Figure 1.1a: Joshua Creek 1320 Wheat Boom Drive Site Plan

1.0 INTRODUCTION AND PURPOSE OF THE ADDENDUM

This Urban Design Brief (UDB) Addendum has been prepared in support of the revised development concept for 1320 Wheat Boom Drive (Block 297). The Addendum supplements the June 2025 UDB and should be read in conjunction with the original document. The updates respond to coordination with Town staff regarding the introduction of approximately 2,200 sq.ft. of neighbourhood-serving commercial space fronting Meadowridge Drive.

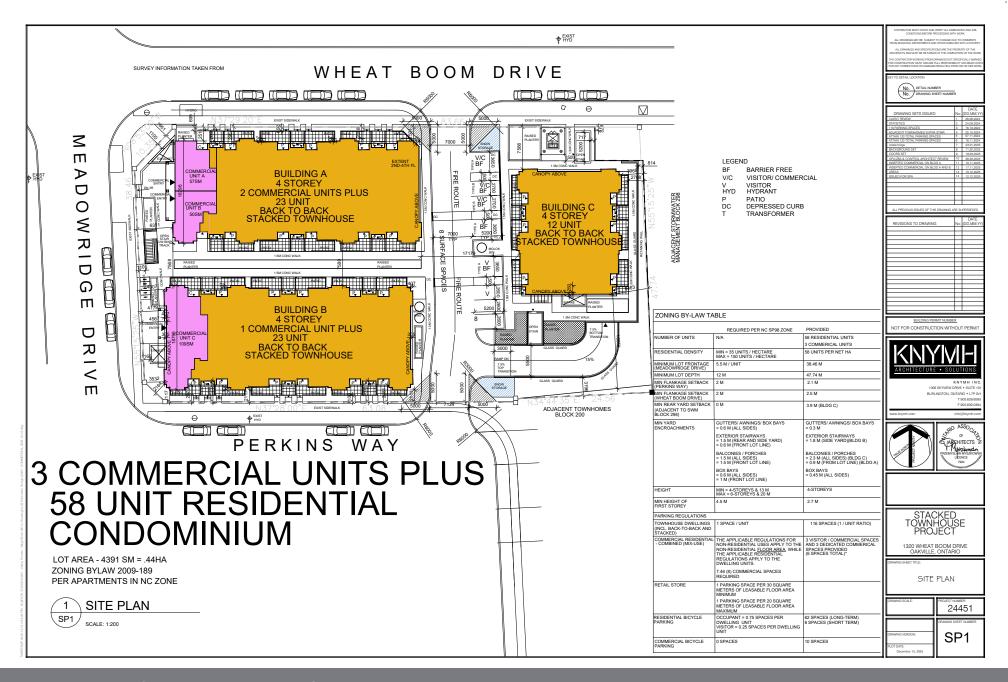
The updated development concept incorporates three small-format commercial units within the ground floor levels of Buildings A and B. These modifications strengthen the Meadowridge Drive frontage, improve the corner condition at Wheat Boom Drive and Meadowridge Drive, and enhance the overall architectural expression of the project.

Figure 5.1a: Joshua Creek 1320 Wheat Boom Drive Landscape Plan

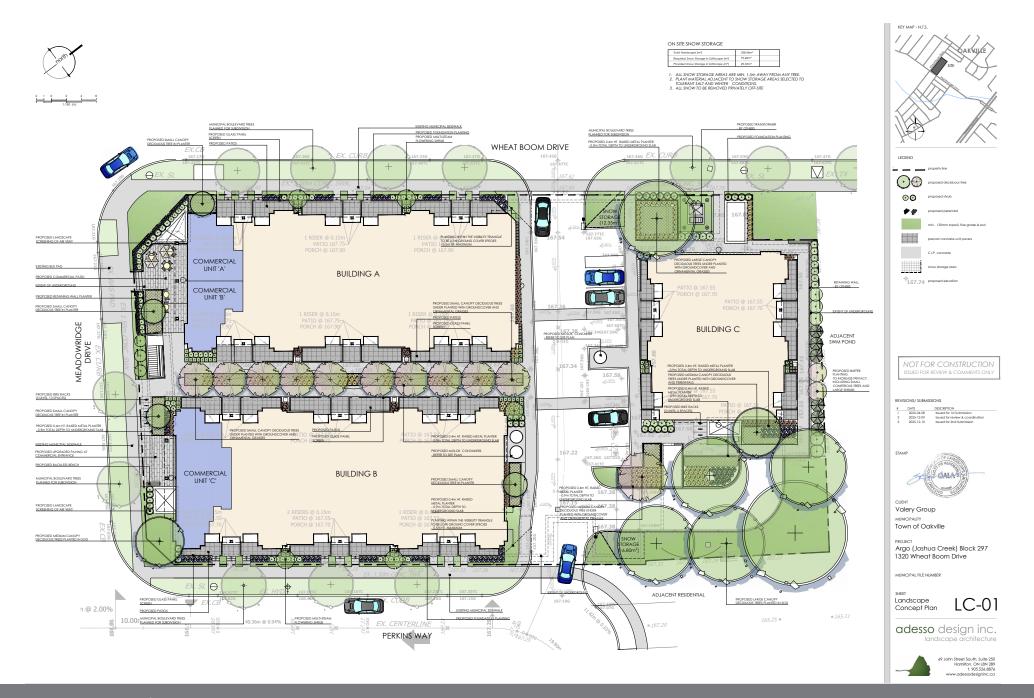
- Transparent glazing is strategically extended across the commercial façades, ensuring strong visual connections between interior activity and the sidewalk.
- A generous, widened pedestrian realm is established along the frontage, creating vital space for seating areas, small outdoor patio spaces, and improved circulation.
- Directly aligned entrances are featured, with the main commercial frontage of Building B providing clear grade-accessible access from the sidewalk to reinforce the pedestrian focus and overall accessibility goals.

The streetscape is softened and defined by enhanced boulevard tree planting and low foundation landscaping, which establishes a strong green buffer and improves the overall aesthetic character

These updates are shown on the Updated Landscape Plan, which illustrates the refined sidewalk edge, planting, and interface with the at-grade commercial units. This figure supersedes the landscape plan figure originally provided in the June 2025 Urban Design Brief.

Figure 4.1a: Joshua Creek 1320 Wheat Boom Drive Block A - Commercial Flankage Elevation

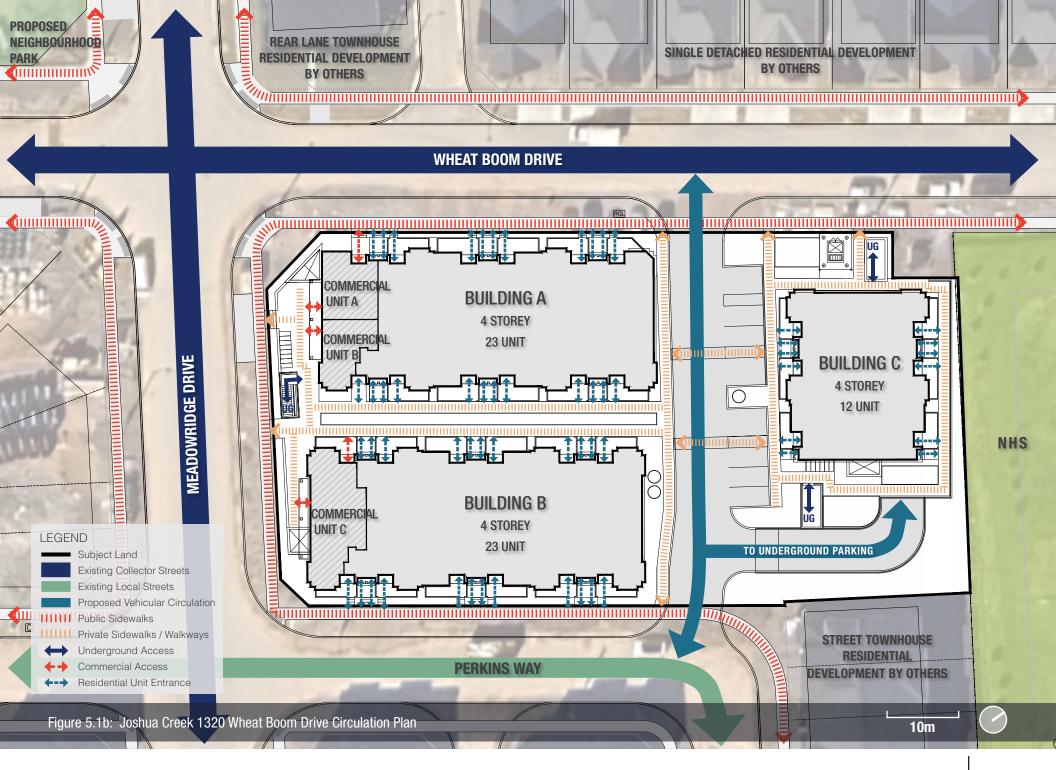
The incorporation of commercial uses has resulted in updates to the building elevations:

- A defined commercial base with increased glazing;
- Material refinements at grade to strengthen human scale;
- Recessed entrances and weather-protected entry points; and
- Updated signage bands integrated cohesively into the façade design.
